LFPCN# 41369

**Subject: Reel Change Notification for Japan made PolySwitch®  
miniSMDC PPTC**

### Comparison Between New Reel and Current Reel:

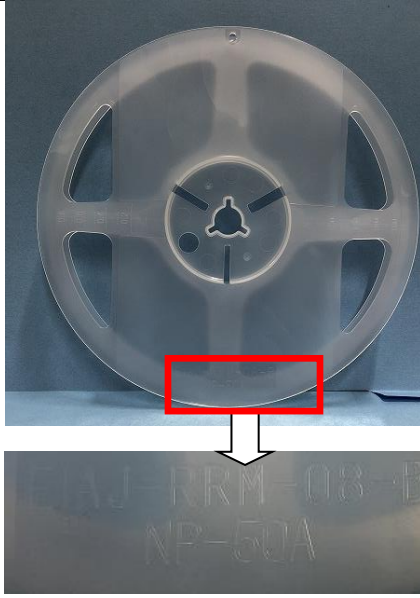
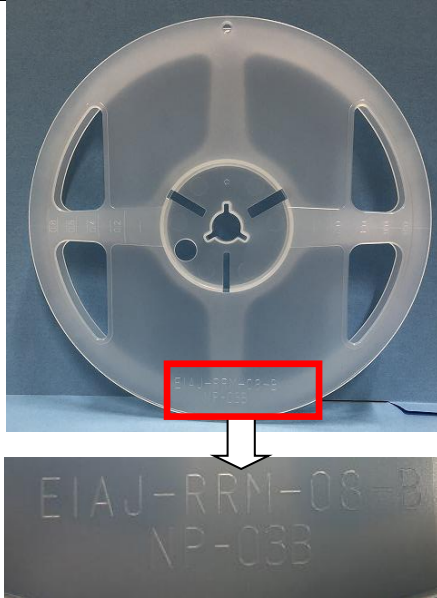
Item	Current Reel	New Reel	Difference
Size	JEITA standard reel (EIAJ RRM 08 B series)  Outer diameter dimension: $180 + 0/-1.5\text{mm}$	JEITA standard reel (EIAJ RRM 08 B series)  Outer diameter dimension: $180 + 0/-3\text{mm}$	Tolerance of outer diameter
Material	PS	PS	None
Appearance			Remark on the reel
